UNITED STATES PATENT AND TRADEMARK OFFICE

APPLICATION NO.	FILING DATE	FIRST NAMED INVENTOR	ATTORNEY DOCKET NO.	CONFIRMATION NO.
10/754,564	01/12/2004	Ola Olofsson	TPP 30887DIV	8238

Office Action Summary

DETAILED ACTION

FIG. 1

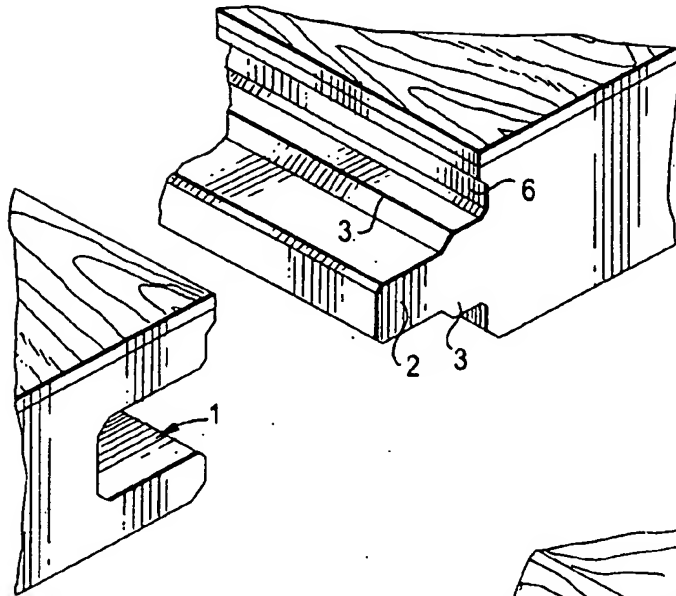
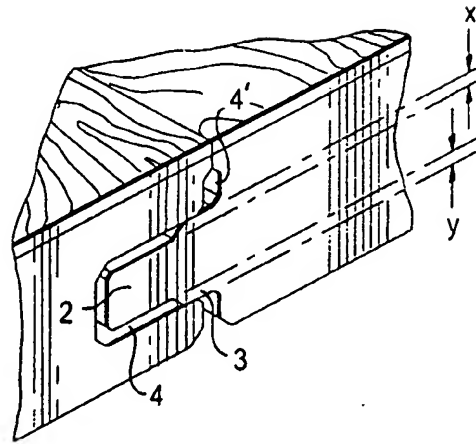
Claim 14. Parasin discloses (figs.1 and 2) a joint formed at a junction between adjacent boards, the joint comprising: a first board (10), comprising an upper surface (upper surface of 10), a lower surface (lower surface of 10) and a groove (32, 35, 37); a second board (11) jointed to the first board, and comprising an upper surface (upper surface of 11), a lower surface (lower surface of 11) and a tongue (16, 20, 24) a first equalizing cavity (upper 46) located adjacent to an upper end of a proximal end (24) of the tongue below the upper surfaces; wherein a distal end (16) of the tongue is smaller than a proximal end (32) of the groove; a second equalizing cavity (bottom 42), formed by a gap between the proximal end (32) of the groove and the distal end of the tongue; and further comprising glue (col.3, ll.15-20) disposed in at least one of the first equalizing cavity and the second equalizing cavity. Parasin does not disclose that the upper surfaces abut. Finkell teaches (fig.2 and col.4, ll.30-35) that upper surfaces of floorboards should abut. One of ordinary skill in the art would have readily recognized that non-abutting floorboards present a greater trip hazard than do abutting floorboards, since abutting boards present no space for pedestrians' shoes to catch. It is further readily apparent that gaps between adjacent floorboards would catch/trap dirt making such flooring harder to clean, which is

Claim 15. Parasin discloses (figs. 1 and 2) a joint formed at a junction between adjacent boards, the joint comprising: a first board (10), comprising an upper surface (upper surface of 10), a lower surface (lower surface of 10) and a groove (32, 35, 37); a second board (11) joined to the first board, and comprising an upper surface (upper surface of 11), a lower surface (lower surface of 11), a tongue (16, 20, 24), a first equalizing cavity (upper 46) located adjacent to an upper end of a proximal end (24) of the tongue below the upper surfaces wherein a distal end (16) of the tongue is smaller than a proximal end (32) of the groove; a second equalizing cavity (lower 42), formed by a gap between the proximal end of the groove and the distal end of the tongue, wherein at least one of the first equalizing cavity and the second equalizing cavity extends to the lower surface (where lower 42 meets the lower surface of 11) of the second board. Parasin does not disclose that the upper surfaces abut. Finkell teaches (fig.2 and col.4, ll.30-35) that upper surfaces of floorboards should abut. One of ordinary skill in the art would have readily recognized that non-abutting floorboards present a greater trip hazard than do abutting floorboards, since abutting boards present no space for pedestrians' shoes to catch. It is further readily apparent that gaps between adjacent floorboards would catch/trap dirt making such flooring harder to clean, which is undesirable. Therefore, it would have been obvious to one with ordinary skill in the art at the time the invention was made to modify the Parisin upper

Claim 17. Parasin discloses (figs.1 and 2) a joint formed at a junction between adjacent boards, the joint comprising: a first board (10), comprising an upper surface (upper surface of 10), a lower surface (lower surface of 10) and a groove (32, 35, 37); a second board (11) jointed to the first board, and comprising an upper surface (upper surface of 11), a lower surface (lower surface of 11), a tongue (16, 20, 24), a first equalizing cavity (upper 46) located adjacent to an upper end of a proximal end (24) of the tongue below the upper surfaces, wherein a distal end (16) of the tongue is smaller than a proximal end of the groove (32); a second equalizing cavity (lower 42), formed by a gap between the proximal end of the groove and the distal end of the tongue, wherein the tongue comprises at least one guiding wedge (top 17 and bottom 17) on an upper surface (upper 22) or a lower surface (lower 22) thereof, whereby the at least one guiding wedge contacts (where 17 meets 33 near 34) an inner surface of the groove. Note that element (18) could also be interpreted as the upper surface. Parasin does not disclose that the upper surfaces abut. Finkell teaches (fig.2 and col.4, ll.30-35) that upper surfaces of floorboards should abut. One of ordinary skill in the art would have readily recognized that non-abutting floorboards present a greater trip hazard than do abutting floorboards, since abutting boards present no space for pedestrians' shoes to catch. It is further readily apparent that gaps between adjacent floorboards would catch/trap dirt making such flooring harder to clean, which is undesirable. Therefore, it would have been obvious to one with ordinary skill in the art at the time the invention was made to modify the Parisin upper surfaces to abut one another, for the

Claim 18. Parasin discloses (figs.1 and 2) a joint formed at a junction between adjacent board, the joint comprising: a first board (10), comprising an upper surface (upper surface of 10), a lower surface (lower surface of 10) and a groove (32, 35, 37); a second board (11) joined to the first board, and comprising an upper surface (upper surface of 11), a lower surface (lower surface of 11), and a tongue (16, 20, 24); and the first board and said second board defining a gap (lower gap between 10 and 11) therebetween; and a hole (bottom 46), in fluid communication (col.3, ll.15-20) with the gap, the hole having an opening below the groove. Parasin does not disclose that the upper surfaces abut. Finkell teaches (fig.2 and col.4, ll.30-35) that upper surfaces of floorboards should abut. One of ordinary skill in the art would have readily recognized that non-abutting floorboards present a greater trip hazard than do abutting floorboards, since abutting boards present no space for pedestrians' shoes to catch. It is further readily apparent that gaps between adjacent floorboards would catch/trap dirt making such flooring harder to clean, which is undesirable. Therefore, it would have been obvious to one with ordinary skill in the art at the time the invention was made to modify the Parisin upper surfaces to abut one another, for the purpose of decreasing trip hazards, eliminating dirt-trapping gaps, and creating a more desirable aesthetic appearance.
